Rampion 2 Wind Farm

Outline Construction Traffic Management Plan (tracked changes)

Revision F

Document Reference: 7.6

Figure 7.6.4d Temporary construction and operational accesses

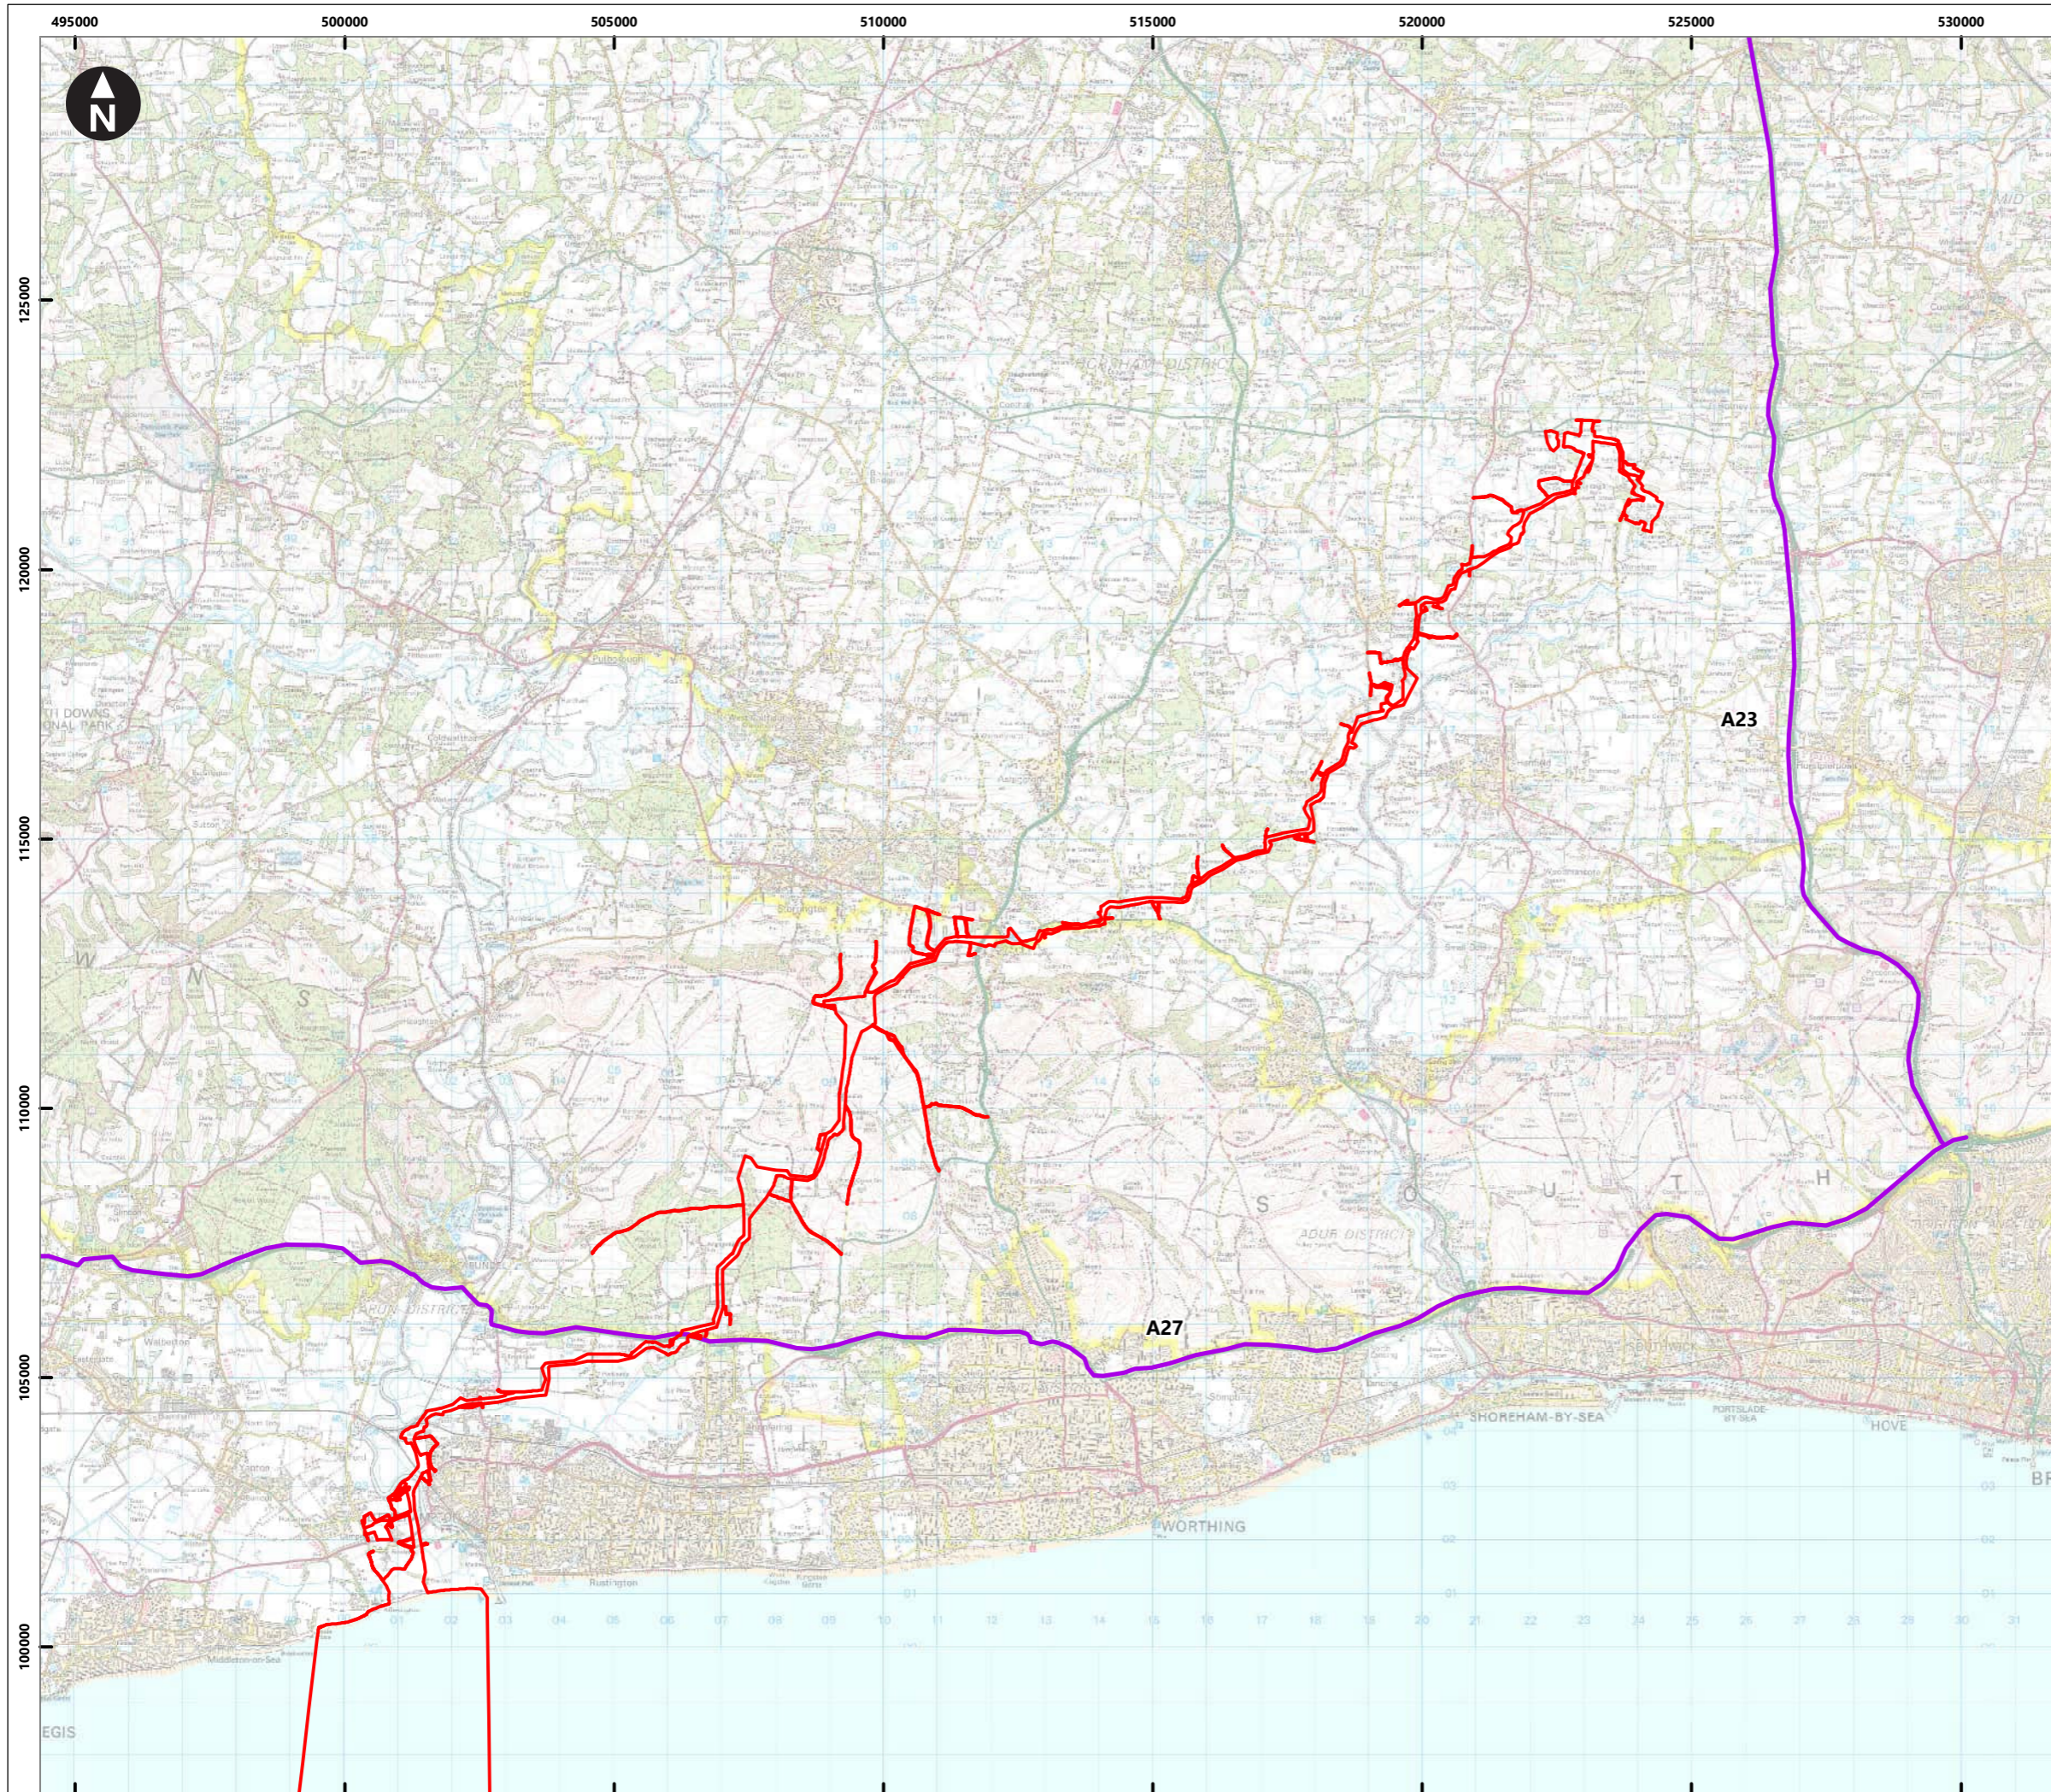
WSSC Local Impact Report Comment	Recommended Action	Applicant's Response to WSSC Local Impact Report	Applicant's amendment to the Outline CTMP
<p>Appendix B, Figure 7.6.4d Temporary Construction and Operational Accesses</p> <p>The access tracks leading from the B2135 at A56 and A57 (construction and operational) are narrow. This could cause vehicles to queue back onto the highway.</p>	<p>Passing places should be provided on the access tracks to enable two vehicles to pass. Alternately traffic management measures may be required to avoid conflicting movements.</p>	<p>[PEPD-009] the Applicant will include additional wording to reflect West Sussex County Council's comments within Appendix B of the Outline Construction Traffic Management Plan [REP1-010]. This will be included in an update to the Outline Construction Traffic Management Plan [REP1-010] at Deadline 3.</p>	<p>Additional wording added to Appendix A under Access A-56 and A-57.</p>

WSCC Local Impact Report Comment	Recommended Action	Applicant's Response to WSCC Local Impact Report	Applicant's amendment to the Outline CTMP
<p>Appendix B, Figure 7.6.4d Temporary Construction and Operational Accesses</p> <p>A67 (construction and operational) and A68 (construction) are both existing. There are no concerns with the accesses themselves, but measures will be required along Wineham Lane to mitigate the additional construction traffic. This may also require measures at the A272 Wineham Lane junction.</p>	<p>Measures will be required to control and avoid conflicting vehicle movements along Wineham Lane Additional measures should be included to assist exiting HGVs both at the Wineham Lane accesses but also at the A272 Wineham Lane junction. Signage may also be required to alert drivers on the A272 to the presence of exiting/turning HGVs. HGV movements should be timed to avoid the network peak hours where possible.</p>	<p>At peak construction the Proposed will generate approximately 40 heavy goods vehicle (HGV) movements per day, which is the equivalent of 3-4 vehicles per hour or one every 15-20 minutes. Based on these peak construction traffic estimates, it is unlikely that the majority of existing traffic will meet an HGV traveling between the A272 and construction site. It is also noted that Wineham Lane has a suitable carriageway width to allow general traffic to pass HGVs on the rare occurrences this occurs. Notwithstanding the above, the Applicant will review this request and provide an update to the Outline Construction Traffic Management Plan [REP1-010] at Deadline 3 where appropriate.</p>	<p>Additional wording added to Appendix A under Access A-67 and A-68 to reference the requirement for a temporary 40mph speed limit on Wineham Lane, which is also included in Section 8.2.</p>

Figure 7.6.6b Local Access Routes

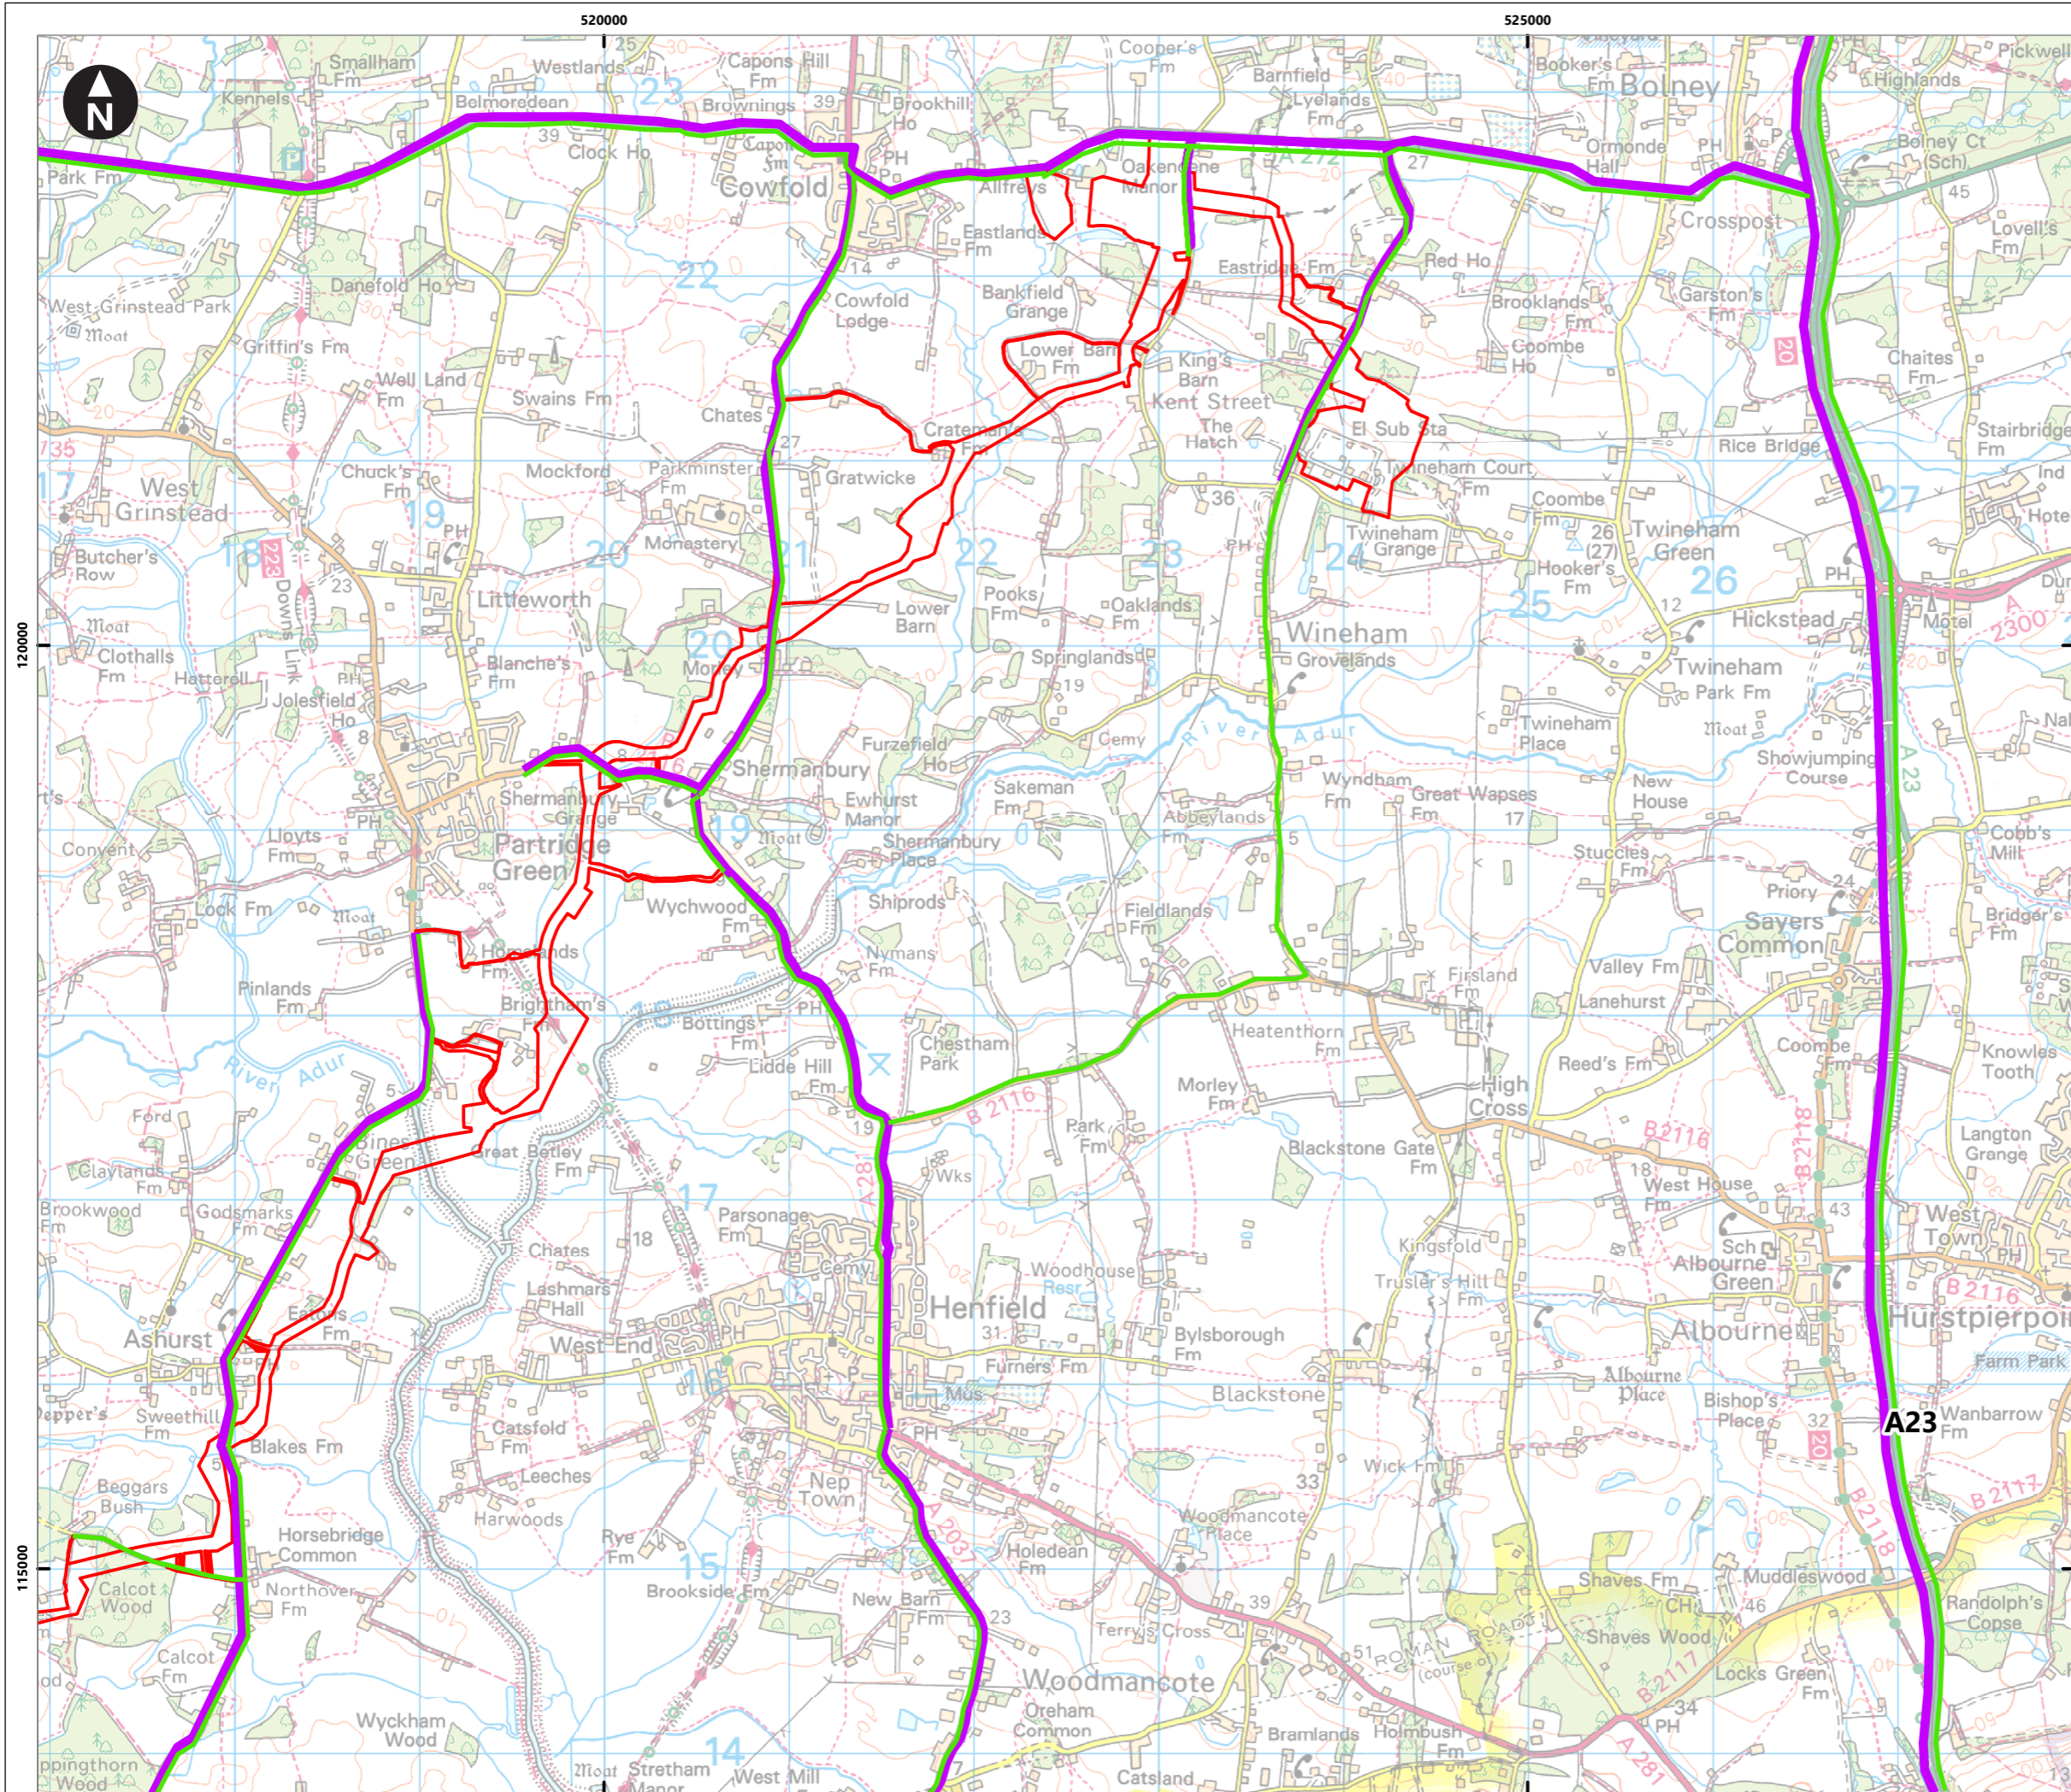
<u>Stakeholder comment</u>	<u>Applicant's response</u>	<u>Applicant's amendment to the Outline CTMP</u>
<p><u>Horsham District Council [REP4-084]</u></p> <p><u>Figure 7.6.6b Local Access Routes (Outline Construction Traffic Management) shows that Storrington AQMA is a potential route for LGVs. Horsham District Council rejects routing of vehicles through Storrington. The Storrington AQMA is the only monitoring site in the district that is still recording concentrations within 10% of the annual mean objective. There are other viable alternative routes for LGVs to access the Washington compound and there should be no need for LGVs to go through the AQMA.</u></p> <p><u>Although the HGV are not proposed to go through the AQMA, there is a proposed HGV route on the A283 that leads to Storrington. More information regarding the number of HGV on this proposed route is required and also on how HGV use will monitor and controlled by the Project Team.</u></p>	<p><u>Figure 7.6.6b of the Outline Construction Traffic Management Plan [REP4-045] shows potential light goods vehicle (LGV) routes to site based upon journey to work information derived upon Census 2011 data. Given that the route through Storrington uses the A283 this is considered the most appropriate route for construction workers traveling to site from areas to the west. Further to this, Table 2-15 within Chapter 32: ES Addendum, Volume 2 of the Environmental Statement (ES) [REP1-006] updated at Deadline 5 shows an estimated peak week construction traffic flow of approximately 150 vehicles day at Receptor O (A283 Storrington Road, Northeast of Sullington Lane), equivalent to less than a 1.0% increase in baseline traffic flows. Noting this estimate includes LGVs associated with access A-33, the number of construction traffic vehicles passing through Storrington will not be significant.</u></p> <p><u>In relation to HGVs, the A283 west of access A-33 is not a permitted HGV route. This is shown on Figure 7.6.6b of the Outline Construction Traffic Management Plan [REP4-045].- Further to this, Appendix A of the Outline Construction Traffic Management Plan [REP4-045] defines that</u></p>	<p><u>Not applicable.N/A</u></p>
